Southampton to London Pipeline Project

Responses to Written Representations -
Local Authorities

Application Document: 8.23

December 2019

Contains OS data © Crown copyright and database right (2019)
OS Licence Number AL100005237 © Natural England copyright

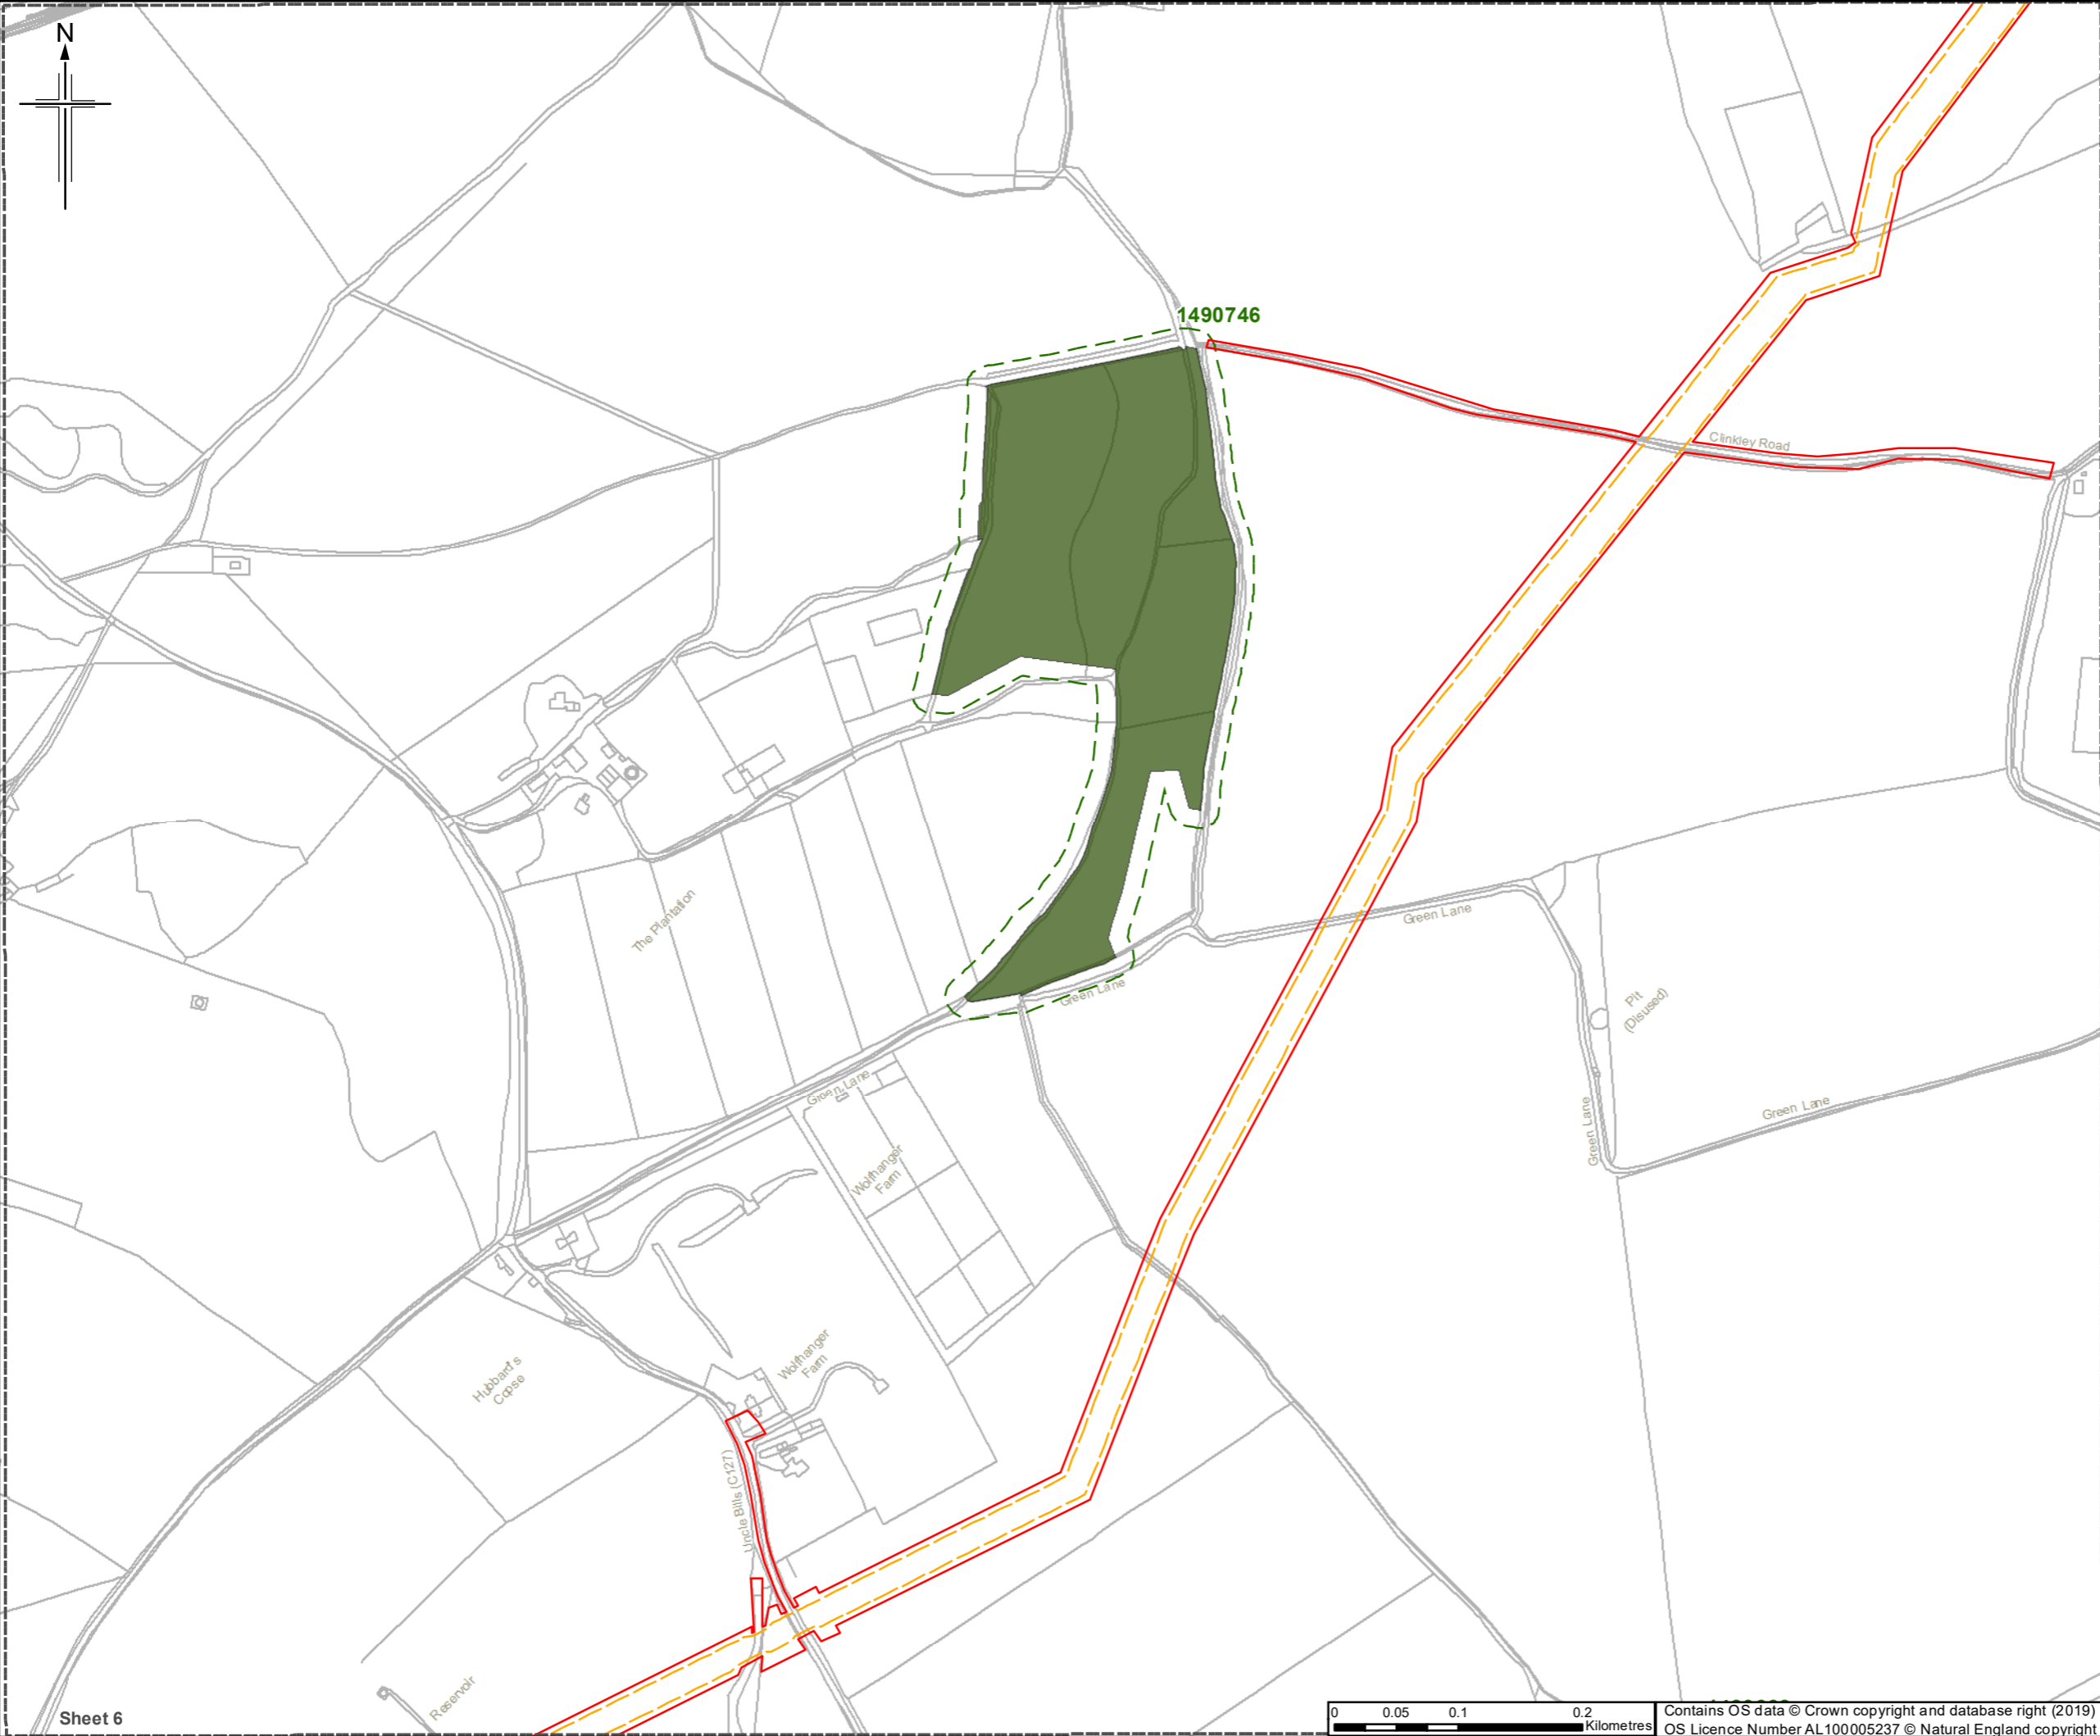
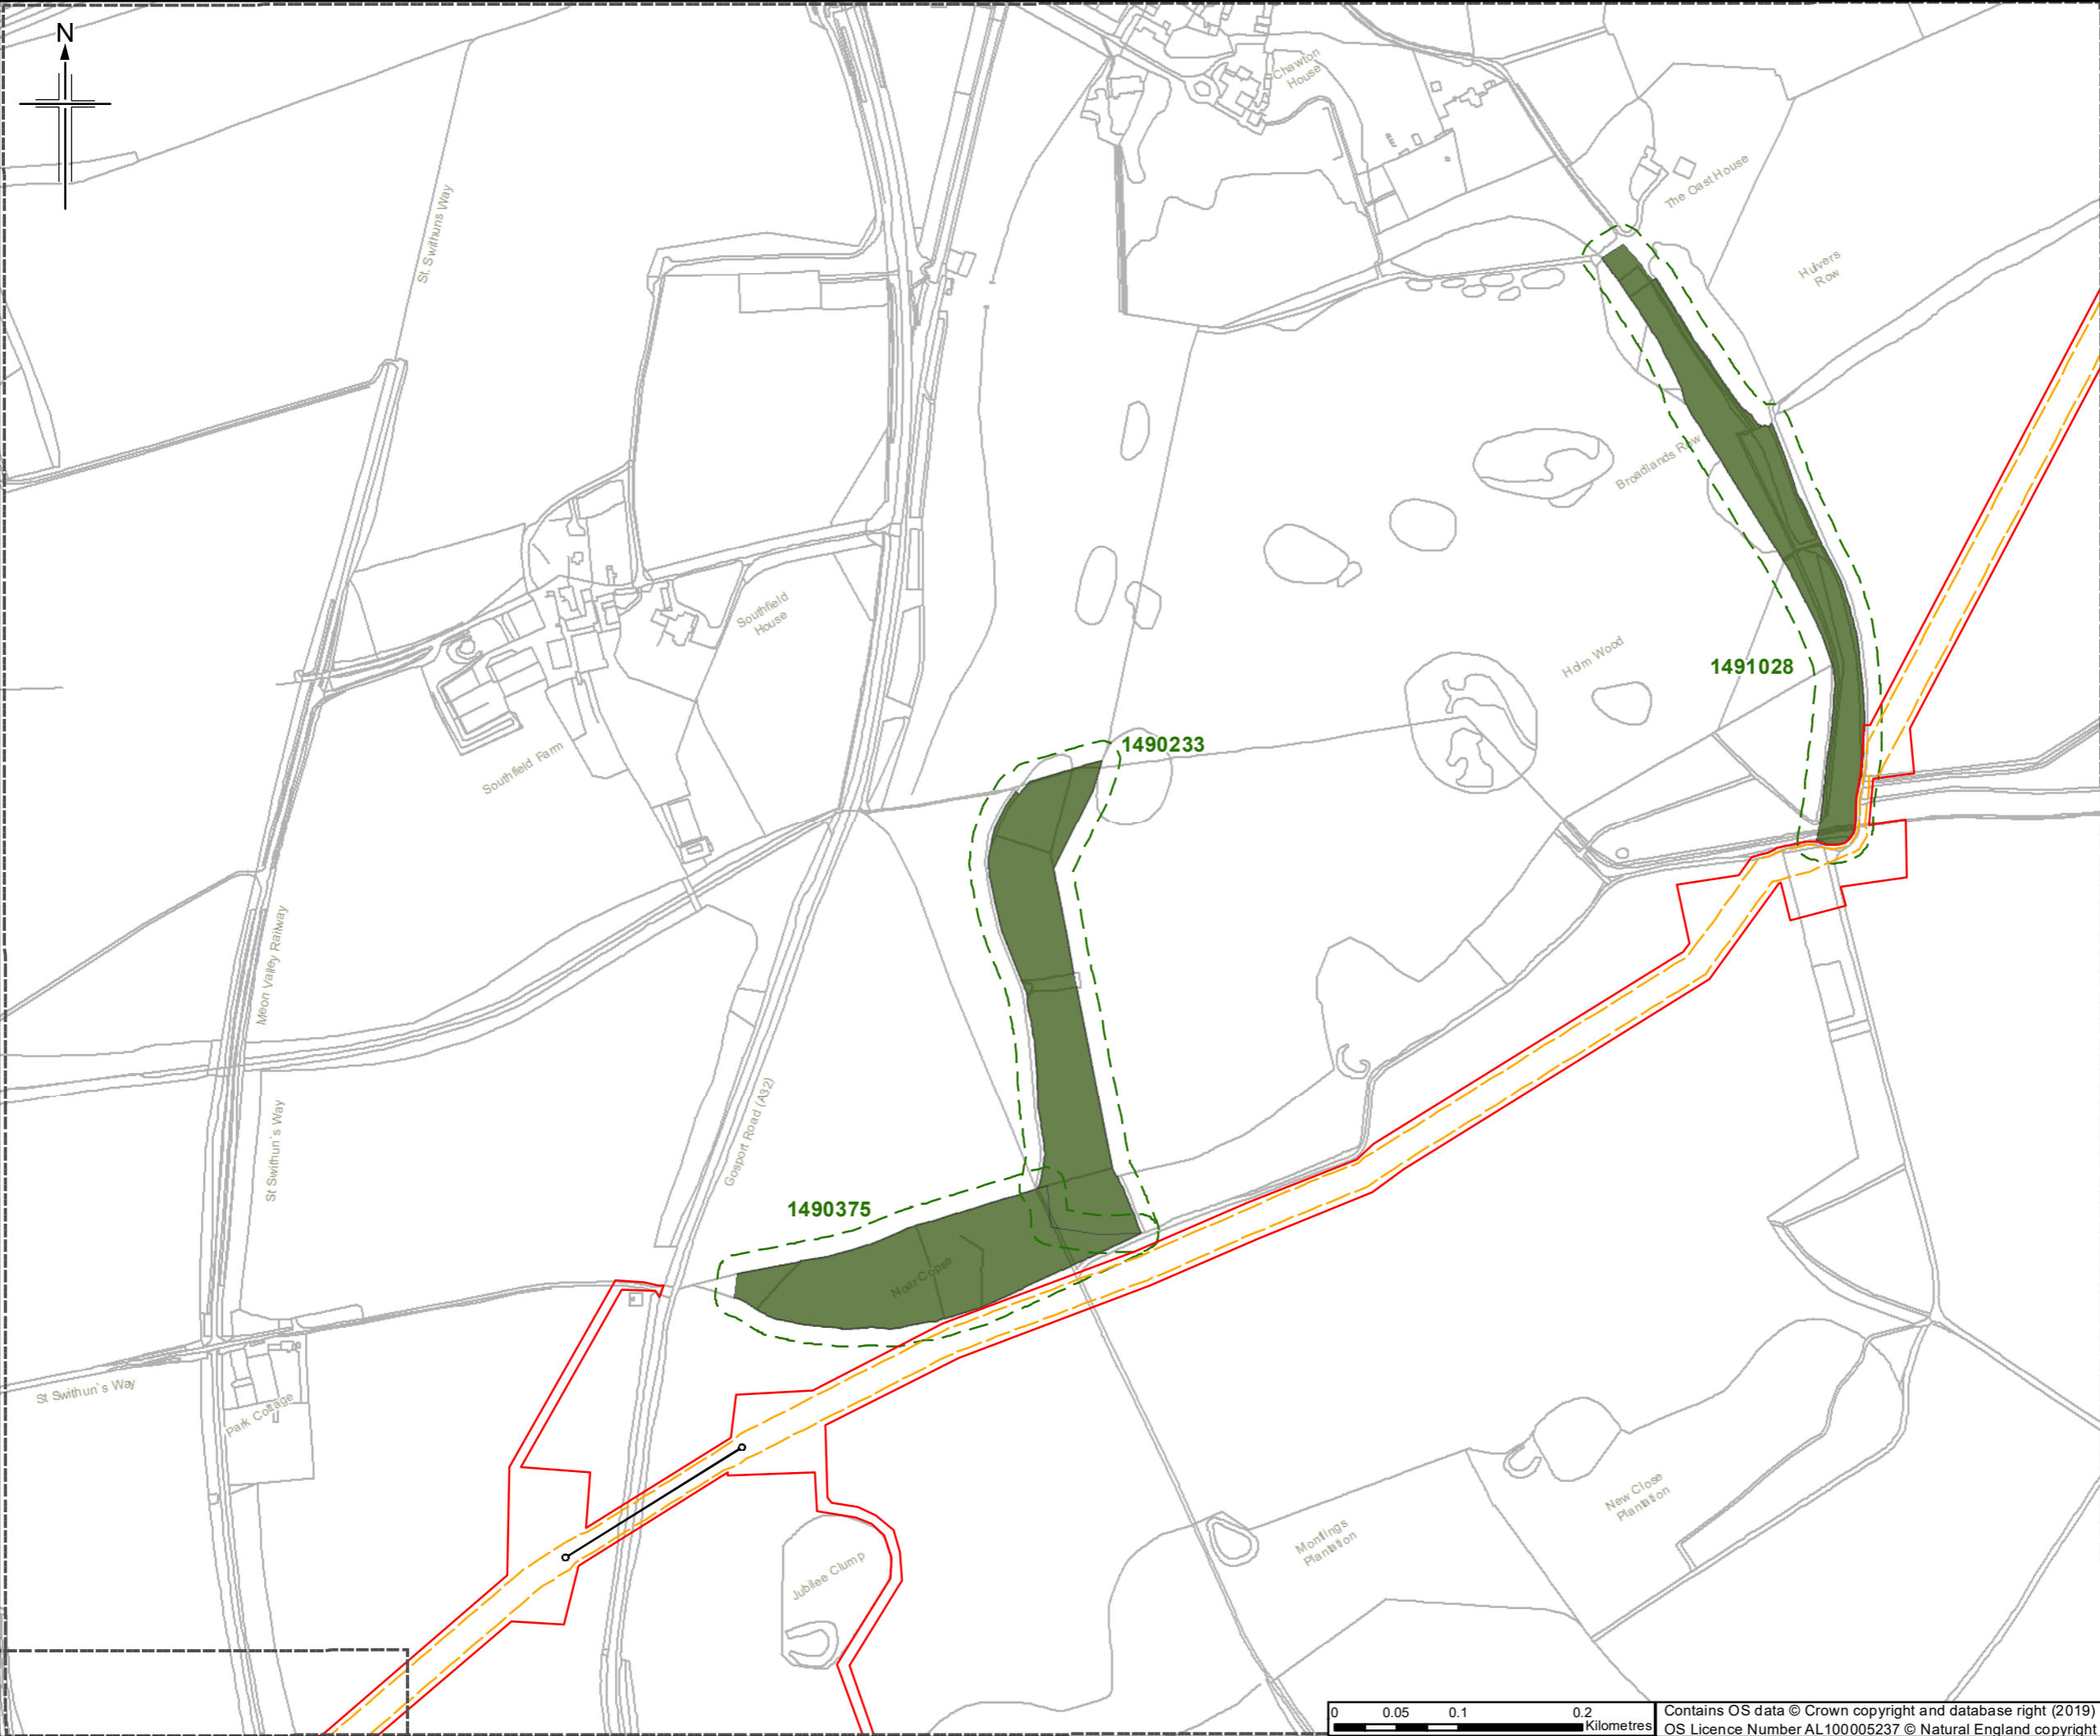
WR Para Ref	Point raised	Applicant response to point raised:
		<ul style="list-style-type: none"> reinstatement hedgerow planting would be relatively quick to establish; reinstatement tree planting would take a little longer to establish, but would have reached approximately 7m in height after 15 years. <p>It is therefore considered that, by year 15, there would be little noticeable change in the landscape character of the National Park when compared to the existing condition, and the effects on the landscape would not be significant.</p>
	<p>In its response to LV.1.25, the SDNPA furthermore requests that the A31/A32 Junction, Northfield Lane (Chawton) logistics hub be added to the list of representative viewpoints set out in the LVIA.</p>	<p>Whilst the Applicant does not consider such a representative viewpoint to be necessary, this has been prepared and is provided at Appendix 1.</p>
<p>Para 3.19 to 3.33</p>	<p>Trees and Woodland</p> <p>The SDNPA sets out concerns regarding potential impacts on, and the applicant's approach to veteran trees and ancient woodland.</p> <p>The SDNPA has requested a plan to identify which of the mitigation hierarchy measures apply to which ancient woodland.</p>	<p>The Applicant has prepared a Technical Note on Ancient Woodland and Veteran Trees (REP2-061) which sets out the approach to reduce the impacts of the project on Ancient Woodland and potential ancient woodland and Veteran Trees and potential veteran trees within 15m of the Order Limits.</p> <p>The Technical Note sets out a hierarchy of mitigation principles, ranging from the use of buffers and ground protection around trees, to the requirement for specialist construction techniques to be used for any unavoidable excavation within root protection areas. The Technical Note has regard to the joint standing advice from the Forestry Commission and Natural England (Ancient woodland, ancient trees and veteran trees: protecting them from development, 2018) when developing the hierarchy of mitigation principles, with avoidance of works within 15m of the edge of ancient woodland and 15m from the stems of veteran trees recommended where practicable.</p>

WR Para Ref	Point raised	Applicant response to point raised:
		<p>Natural England has signed a SoCG with the Applicant (REP1-005), Section 3 of which sets out agreement on matters including:</p> <ul style="list-style-type: none"> • avoiding classified ancient woodland and reducing impacts on potential ancient woodland; • the mitigation proposed in Chapters 7 (Application Document APP-047) and 16 (Application Document APP-056) of the ES; and • working methods in relation to ancient woodland and veteran trees. <p>The Forestry Commission has signed an SoCG with the Applicant (REP2-025), Section 3 of which sets out agreement on matters including:</p> <ul style="list-style-type: none"> • that the proposed approach to mitigating effects on Ancient Woodland, potential ancient woodland and veteran trees, as described in the ES (Application Document APP-056) and the further information included in the Ancient Woodland and Veteran Trees Technical Note (REP2-061) are appropriate; • that appropriate measures have been taken to identify all areas of Ancient Woodland, and areas of Potential Ancient Woodland that do not appear on Natural England's Ancient Woodland Inventory; and • that the Order Limits avoid all areas of existing classified Ancient Woodland. <p>In addition, the Applicant has prepared a plan showing the locations of Ancient Woodland, potential ancient woodland, Veteran Trees and potential veteran trees (see Figure 1 and 2 appended to this document).</p>
